FE160 FE METER

ISSUE: 1-16-73

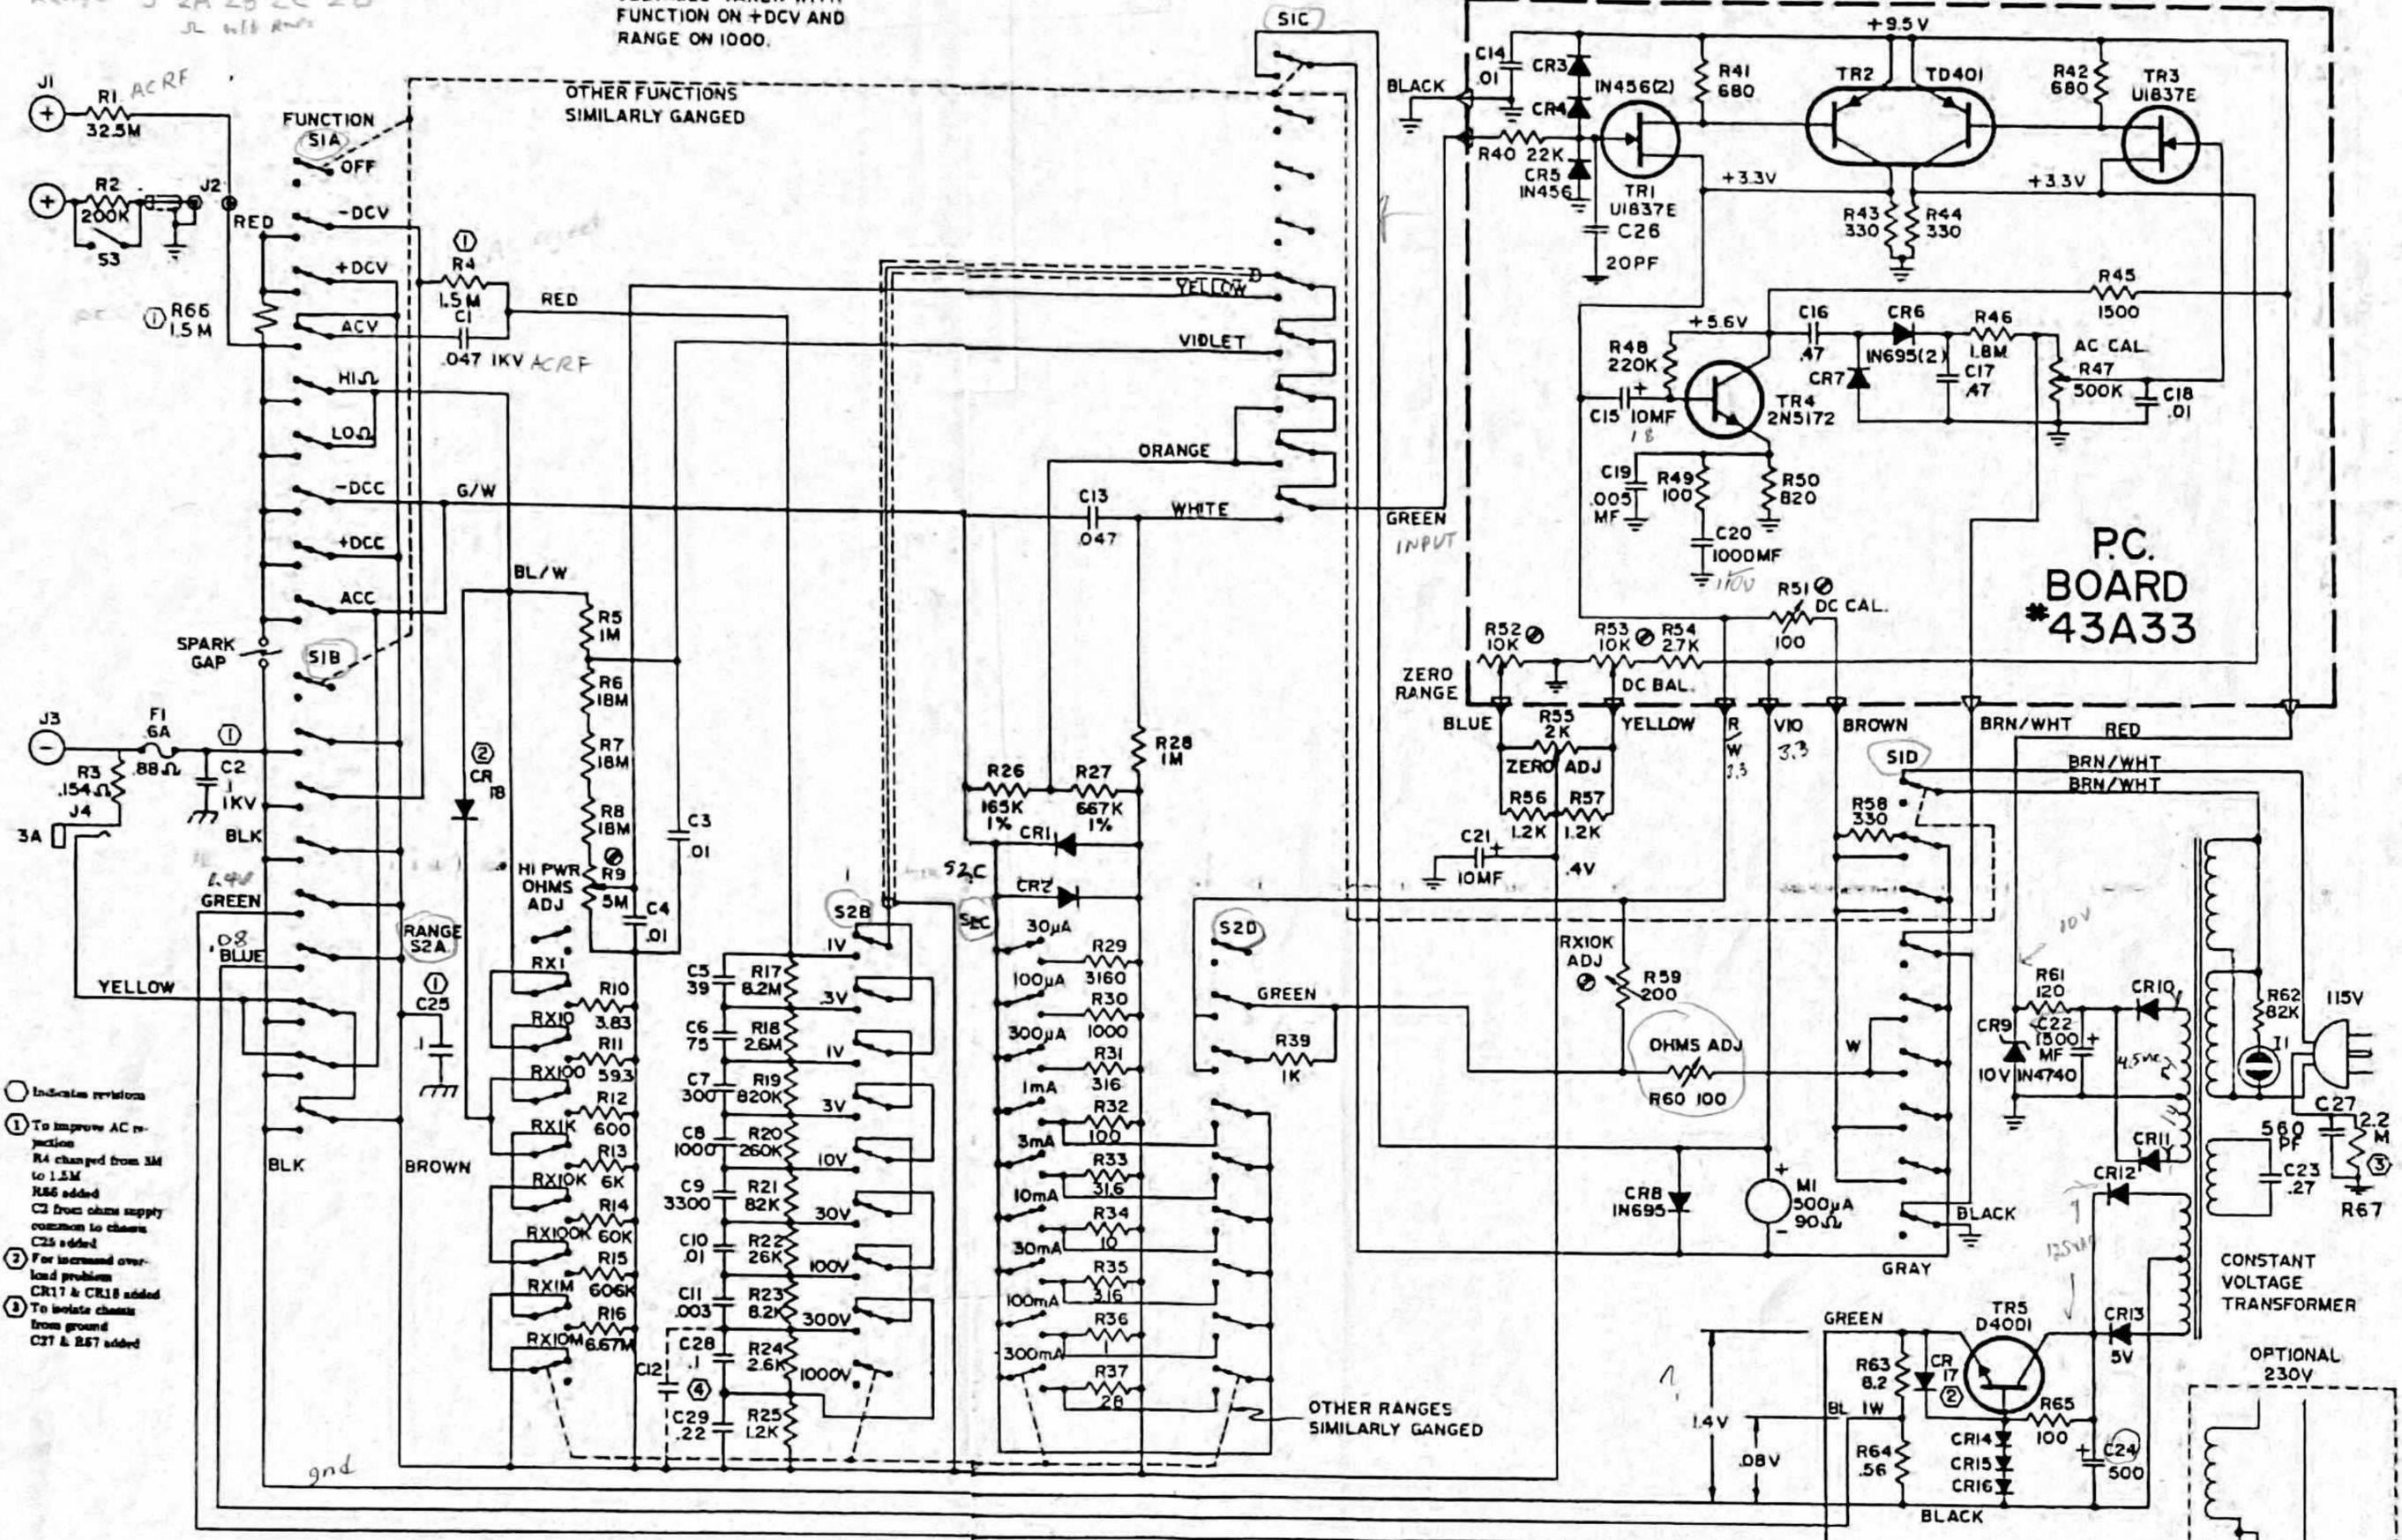
- Indicates revisions
- ① To improve AC rejection
R4 changed from 3M to 1.5M
R86 added
C3 from ohms supply common to chassis
C25 added
- ② For increased overload protection
CR17 & CR18 added
- ③ To isolate chassis from ground
C27 & R67 added

- ④ RUN 10-C12 ELIMINATED
 C28 AND C29 ADDED
 C6 CHANGED FROM 91pf TO 75pf
 R2 CHANGED FROM 100K TO 200K
 R65 CHANGED FROM 180 TO 100
 C19 FROM 100PF TO .005 MF
